Proposed housing at the Lynwick Street/ Guildford Road junction, Rudgwick

Landscape Statement

Ref: 500193

1.1.5 This Landscape Statement provides a commentary on the CR comments and the additional assessment material that has been requested by Place Services.

Plate A: Landscape Capacity of Study Areas for Housing Development, extracted from Horsham District Landscape Capacity Assessment

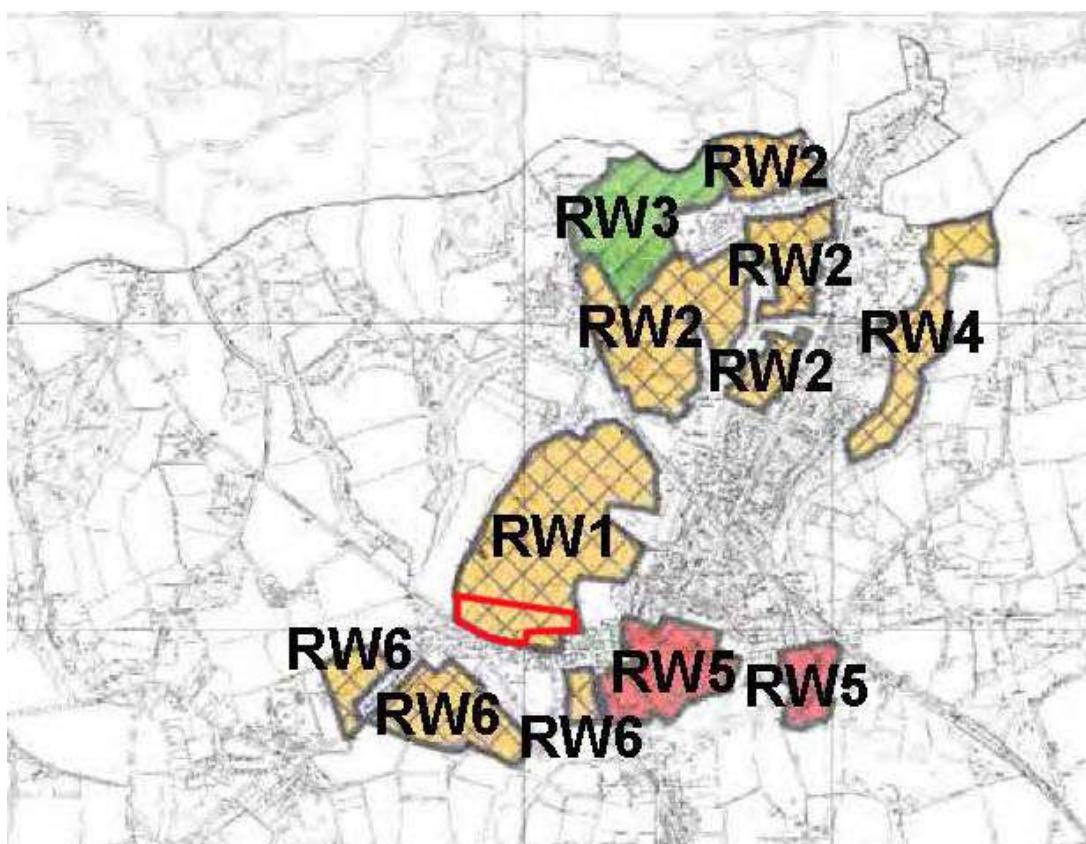
3.1.3 We also note that the Horsham District Landscape Capacity Assessment identified that Area RW1 (**Plate A** below), an extensive area of land on the western side of Rudgwick, has a Low-Moderate overall landscape capacity to accommodate small-scale housing (defined in the study as development of no more than 60 dwellings).

3.1.4 The Application Site lies in the far southern part of the RW1 Assessment Area. It has a relatively high capacity to accommodate new housing compared to the overall landscape capacity for the whole of Area RW1 as it would, using the study assessment criteria, “*avoid extending onto the higher and more open land beyond*”, achieve a good landscape fit in terms of integrating with the “*existing linear settlement pattern of Bucks Green*” and be located in an area with reduced tranquillity close to the A281.
